Department of Energy

The Honorable Peter S. Winokur
Chairman
Defense Nuclear Facilities Safety Board
625 Indiana Avenue, NW, Suite 700
Washington, DC 20004

This letter responds to your September 13, 2011, letter regarding ammonia hazards at the Hanford Site Waste Treatment and Immobilization Plant (WTP). Your letter expressed the Defense Nuclear Facilities Safety Board's (Board) concerns that the ammonia system controls, as currently designed, may not adequately protect workers or other WTP facilities; and therefore, asked for a report addressing those concerns. The report you requested is enclosed.

WASTE TREATMENT AND IMMOBILIZATION PROJECT RESPONSE TO THE DEFENSE NUCLEAR FACILITIES SAFETY BOARD DESIGN OF AMMONIA CONTROLS

Figure 1: 2001 to 2010 Wind Speed Cumulative Distribution

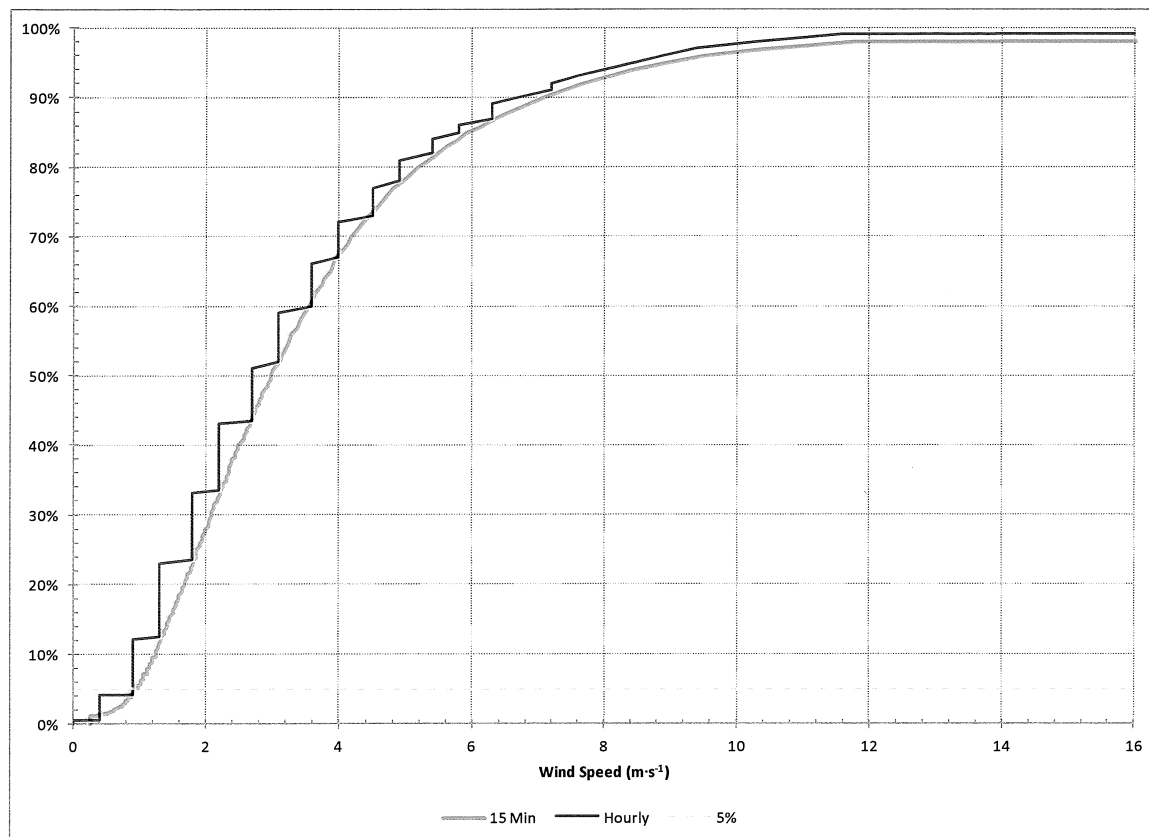
Calculation 24590-WTP-Z0C-W14T-00023 employs a puff-plume model to evaluate airborne ammonia dispersion using 10 years of hourly-averaged meteorological data obtained from the Hanford Weather Station (HWS). The Defense Nuclear Facilities Safety Board (Board) noted in its letter that because the ammonia puff duration is short, the wind speed

determined from hourly data may not be appropriate. To address this issue, the WTP has obtained 15-minute data for the last 10 years from the HWS and has determined the associated fifth percentile wind speeds. WTP has compared the 15-minute average wind speeds with those that had been based on hourly data. The results of this comparison for selected locations where ammonia releases could occur are shown in Table 1.

As can be seen, in all but one minor case, the 15-minute data yielded higher fifth percentile wind speeds, indicating that the original use of the hourly data was conservative and the one exception is on the order of a one percent difference. Because the ammonia puff release is a short-duration event, use of the 15-minute data is the more technically correct approach. Consequently, a forthcoming revision to the MCR habitability calculation 24590-WTP-Z0C-W14T-00023 will use the 15-minute Hanford 200 East Area meteorological data wind speeds for the short-term puff portion of the release. For the longer-term plume portion of an ammonia release, the hourly-averaged data will continue to be used.

The HWS determines hourly data by calculating a vector rather than a scalar average of the four 15-minute intervals in the hour, rounding the result to the nearest mile per hour. The effect of this can be seen in the cumulative distribution curve shown in Figure 1, where the rounded hourly data produces a jagged step curve that results in lower wind speeds than the smooth curve produced by the 15-minute data, and explains why data yields higher wind speeds.
